- .1 Cover Page – Addendum No.6 – 1 page;
 - .2 Civil Addendum C2 dated March 28, 2018 – 1 page;
 - .3 Architectural Addendum A4 dated March 28, 2018 – 20 pages including 9 drawings;

Architectural Addendum A4

PROJECT TITLE	East Hants Aquatic Centre
---------------	---------------------------

DRAWING TITLE
SECTION DETAILS -
EXTERIOR

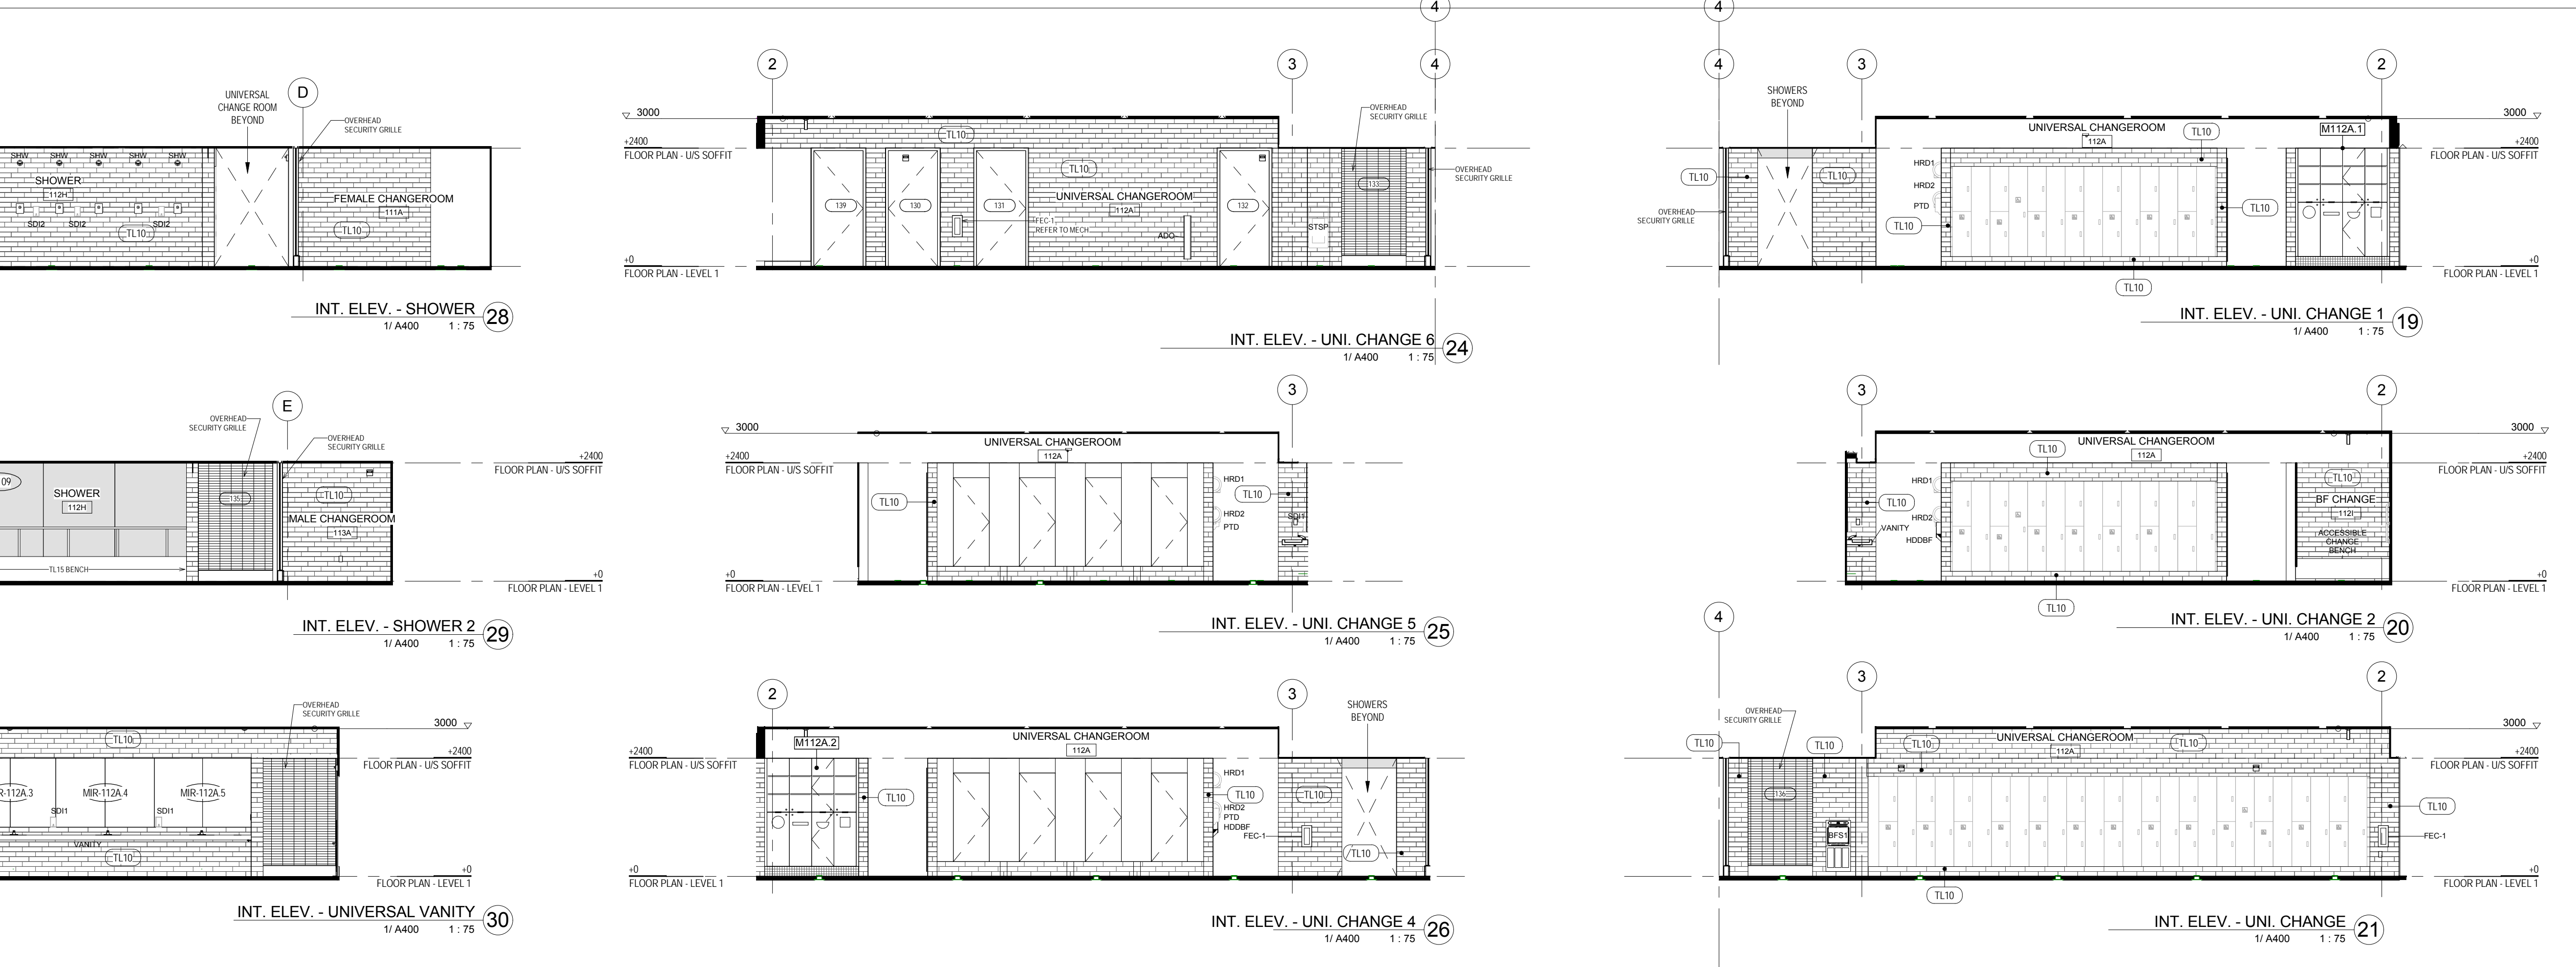
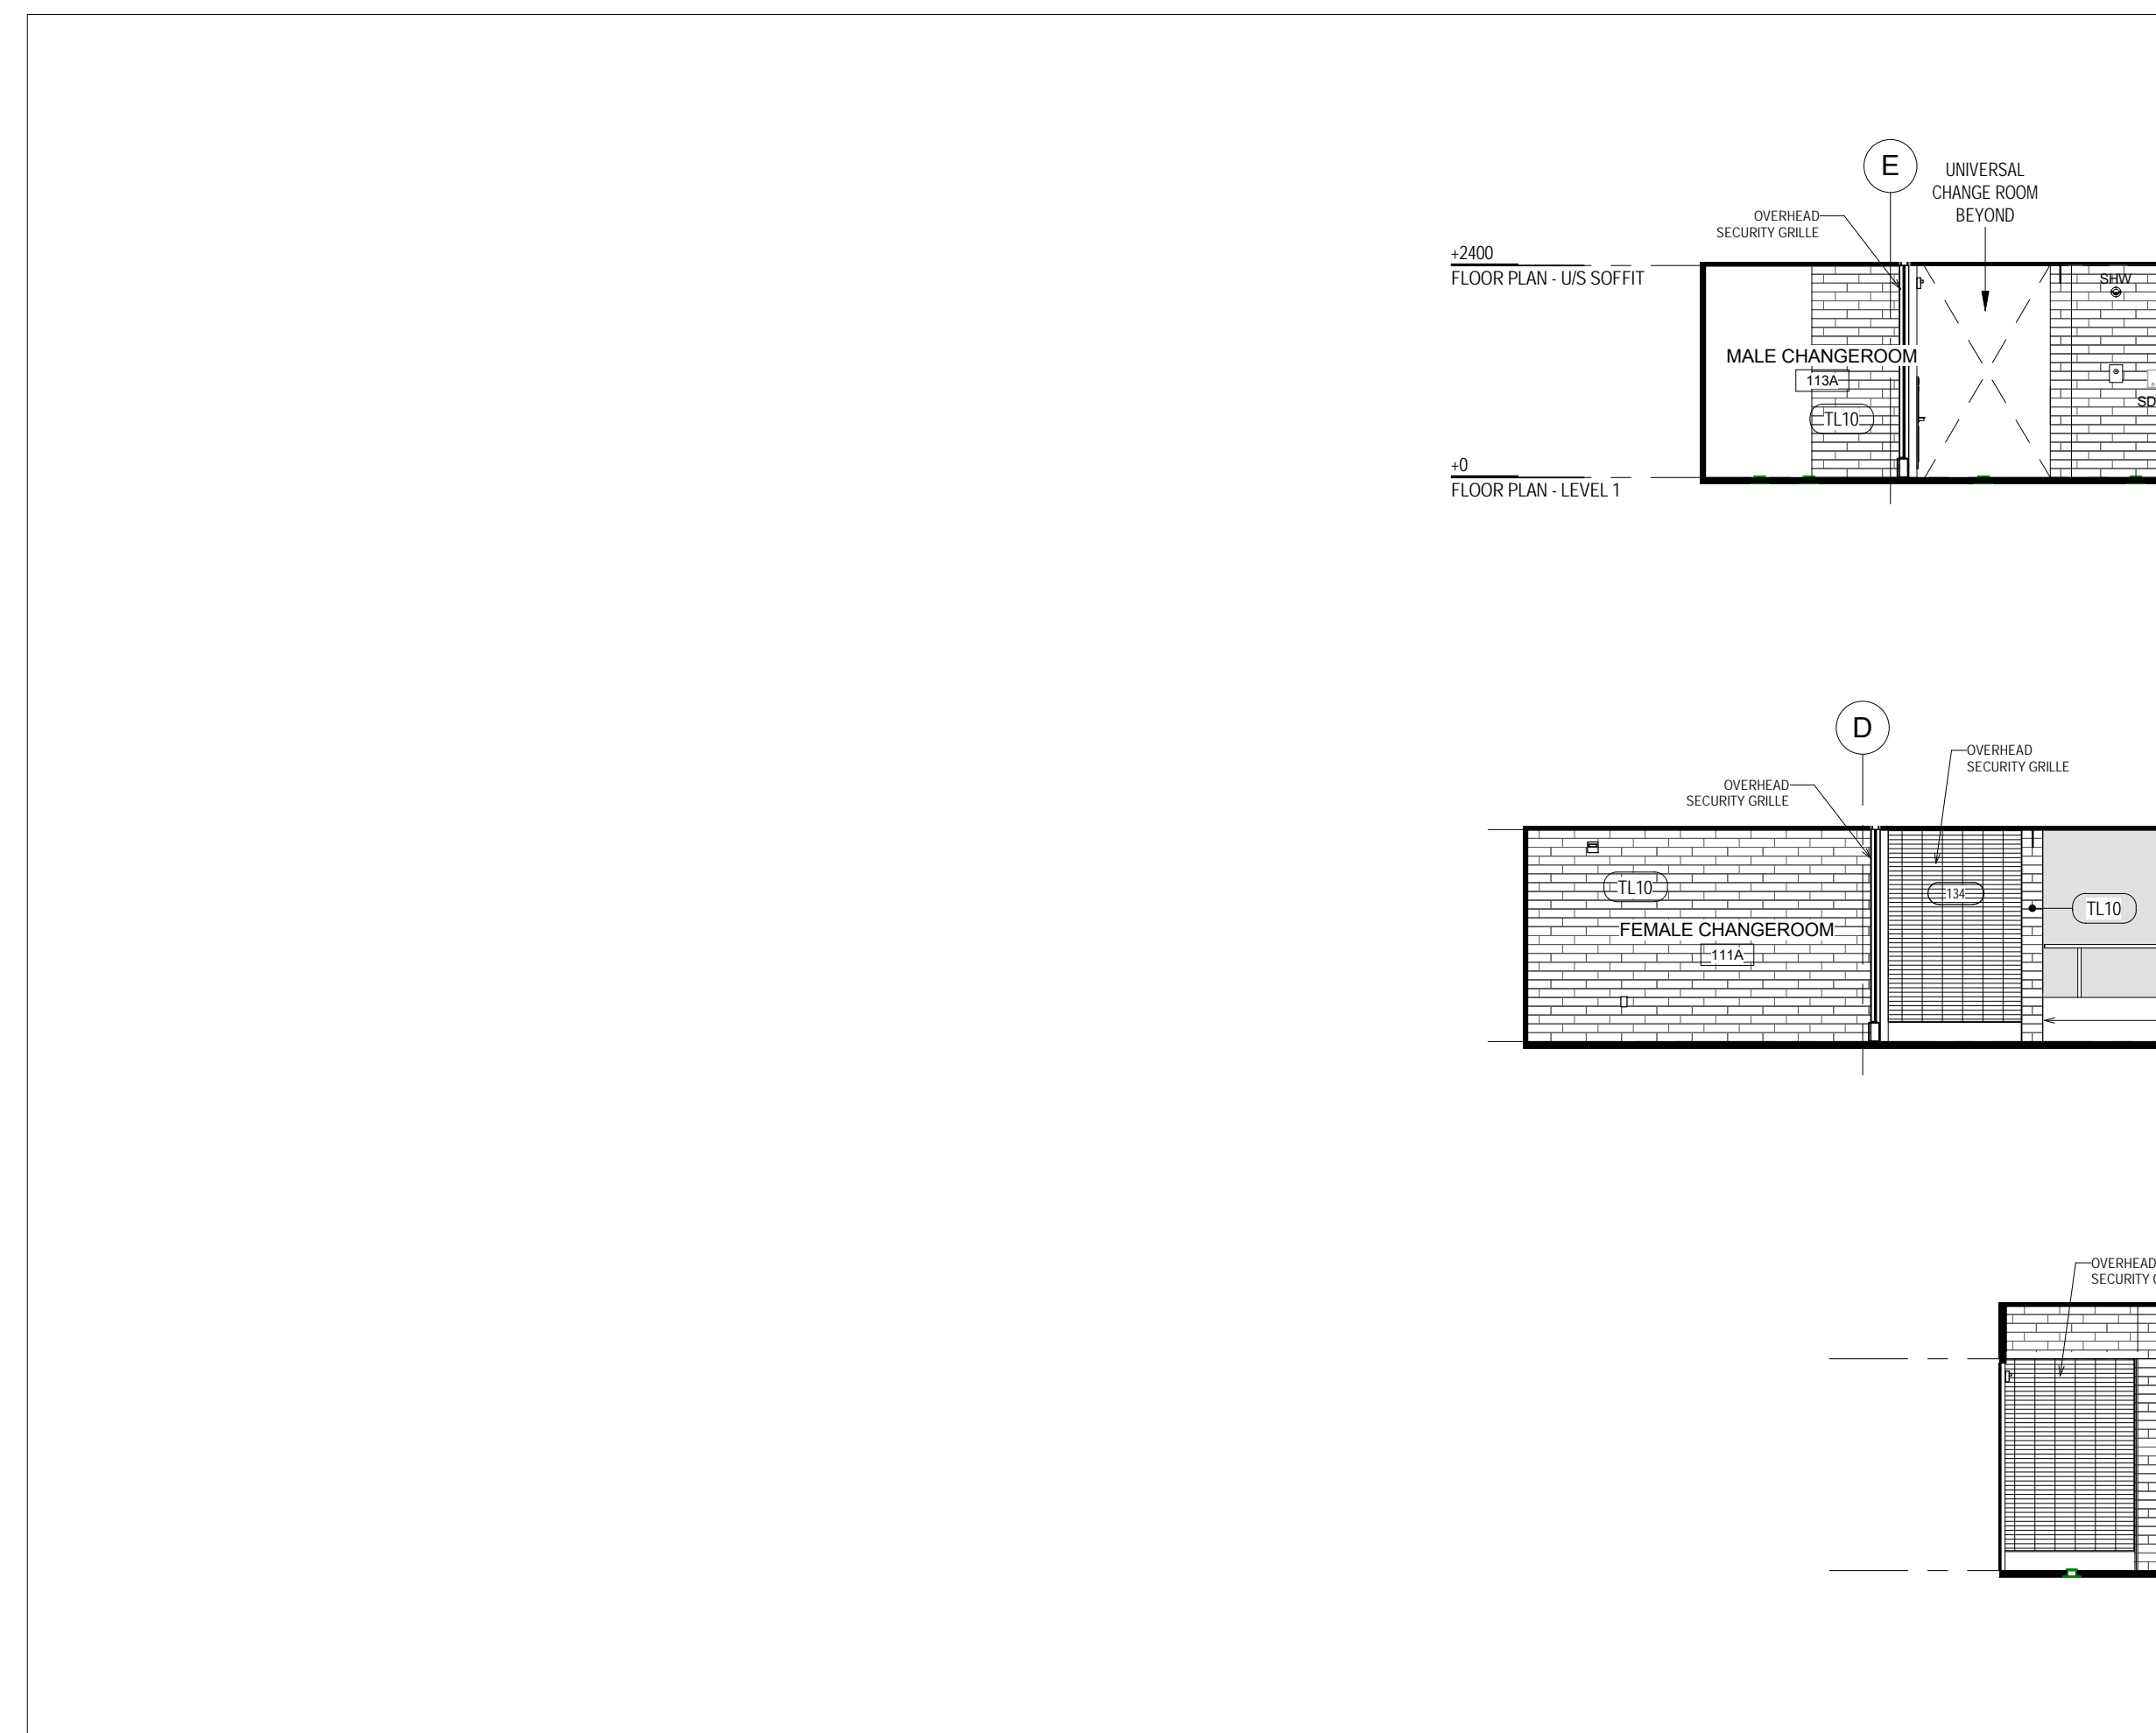
- .1 Detail 5/A330: REMOVE ROLLER SHADE and EXTEND MLT1, substrate and framing to face of curtainwall head.

DRAWING TITLE
INTERIOR ELEVATIONS

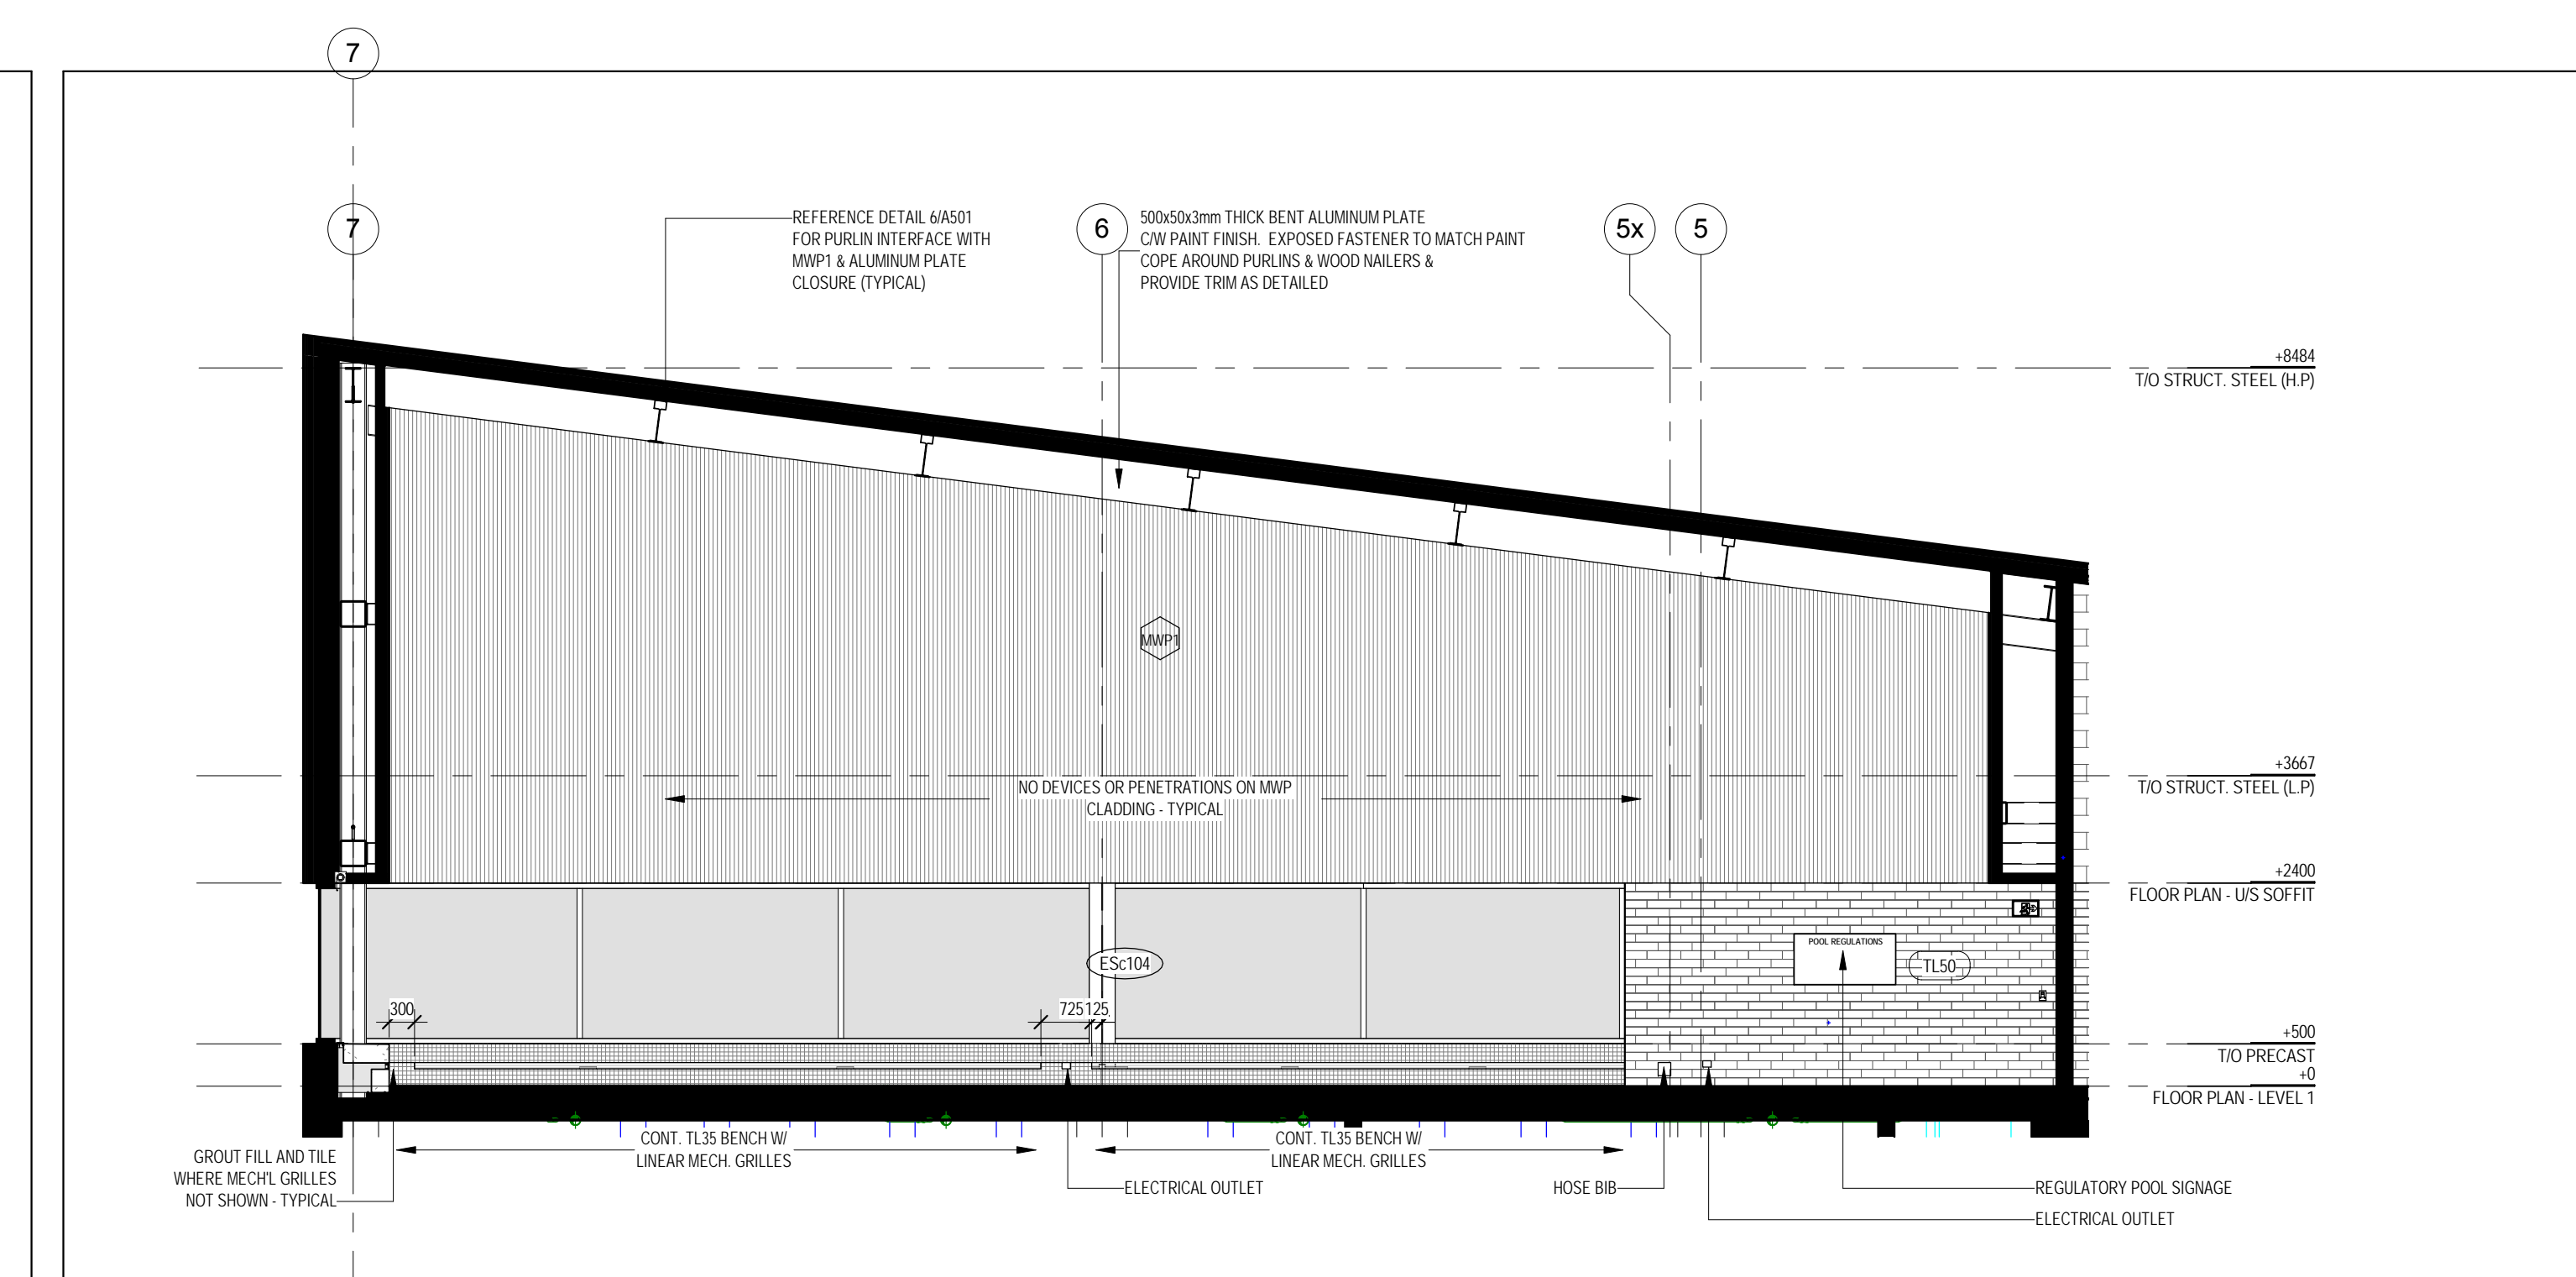
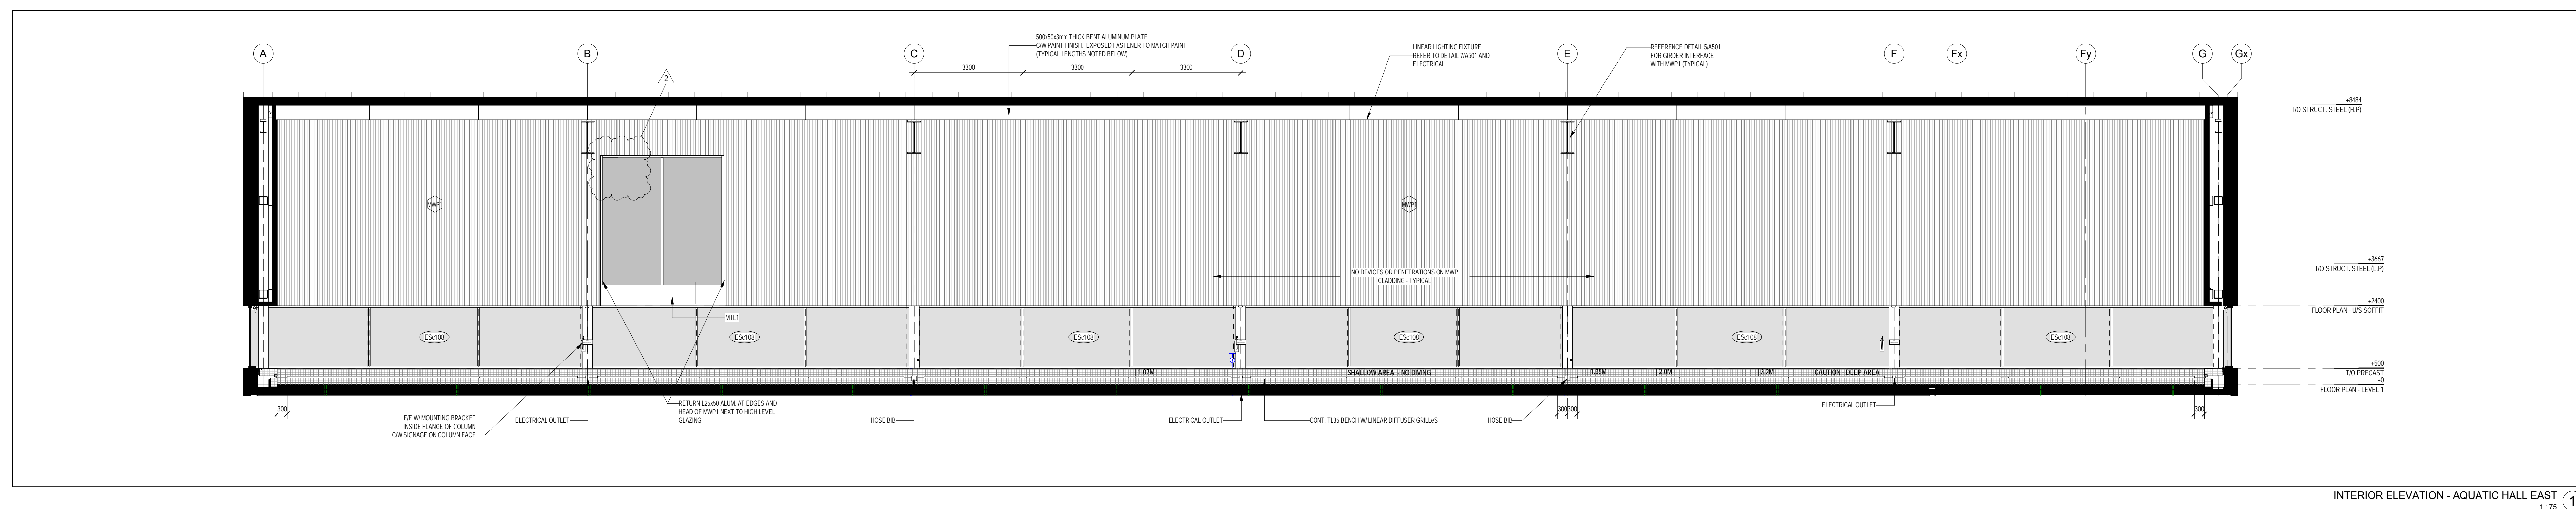
- .1 Detail 9/A500: ADD TV / Mount.
 - .2 Detail 12/A500: ADD TV / Mount.
